Request for Class II Permissive Change(C2PC)

FCC ID: VG8XM025FXX-Y

Data: 2020-8-30

1. Changed Mother -board as below.

The original top /Bottom view (AM Series)

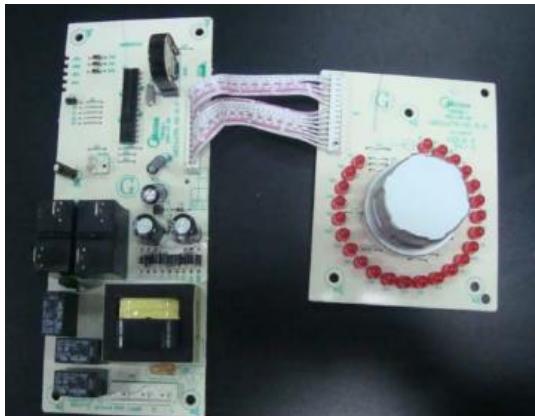
The new mother board is a switching power supply instead of the original linear transformer scheme. They have the same input, output and power except for PCB layout and some electronic component differences.
